REMARKS

VERSION WITH MARKINGS TO SHOW CHANGES MADE**IN THE SPECIFICATION**

Fig. 1

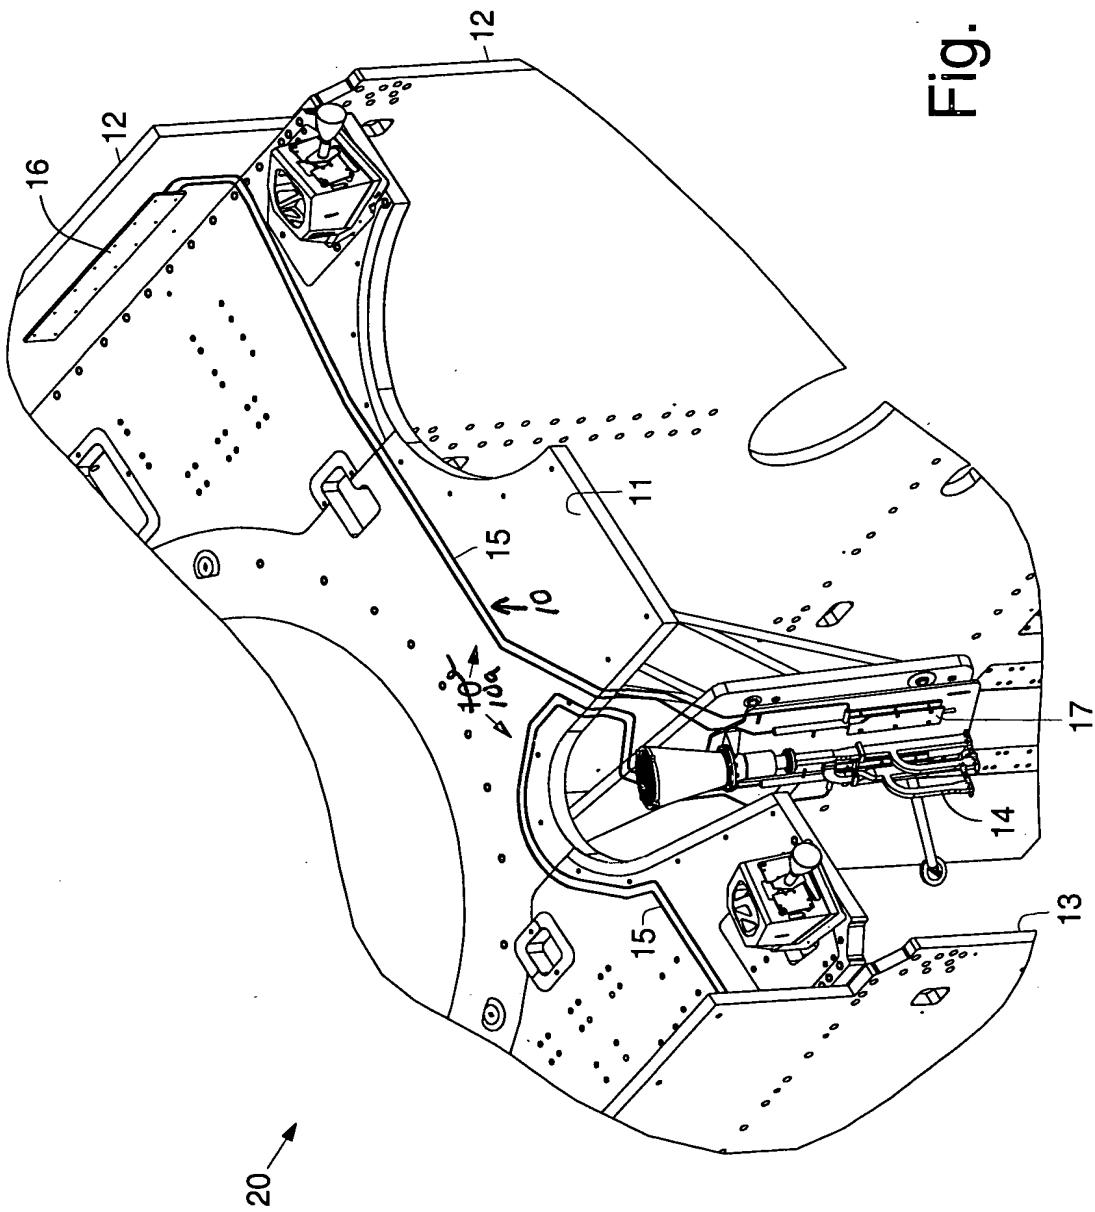
The drawings were objected to because, in the Examiner's opinion, reference characters "10", "14" and "15" have been used to designate at least two different devices. The undersigned attorney apologizes for these errors. The specification and drawings have been amended in a manner that addresses the Examiner's issues. However, it is respectfully submitted that reference numeral "15" is not used to designate more than one component. Reference numeral "15" is used in the specification to designate "flexible thin walled tubing 15" comprising "a loop heat pipe transport line 15", "thin walled tubing 15", and "flexible tubing 15". These alternative recitations refer to the same component. It is respectfully submitted that reference numeral "15" is not used to designate any other component. Enclosed herewith are amended drawing figures containing proposed amendments marked in red ink. Also enclosed is a set of replacement reproducing masters having the amendments included therein. Entry of the amended drawings and replacement reproducing masters is respectfully requested.

Referring to the drawing figures, Fig. 1 is a perspective view of a portion of a spacecraft 20 and illustrates an exemplary heat transfer system [10] 10a, (or heat dissipation system 10a) in accordance with the principles of the present invention. Fig. 2 is a side view of the spacecraft 20 and heat dissipation system [10] 10a shown in Fig. 1.

The spacecraft 20 illustrated in Figs. 1 and 2 comprises an Earth deck 11 that is a transverse panel of the spacecraft 20 on which heat dissipating equipment (heat sources 14) are located. The Earth deck 11 attached to North and South radiator panels 12, 13. Exemplary heat dissipating equipment 14 or heat source 14 is shown as a Ku-band feed horn 14, although there are other heat sources that are located remotely from either of the radiator panels 12, 13, [14,] or from heat dissipating apparatus such as heat pipe panels, RF loads, output multiplexer (OMUX) filters, RF switches and circulators (not shown).

The exemplary heat transfer system [10] 10a comprises a loop heat pipe 10. The loop heat pipe 10 comprises flexible thin walled tubing 15 comprising a loop heat pipe transport line 15 that is coupled between one or more evaporators 17 that are thermally coupled to the heat source 14 (Ku-band feed horn 14) and one or more condensers 16 that are thermally coupled to one or more of the radiator panels 12, 13 [, 14,].
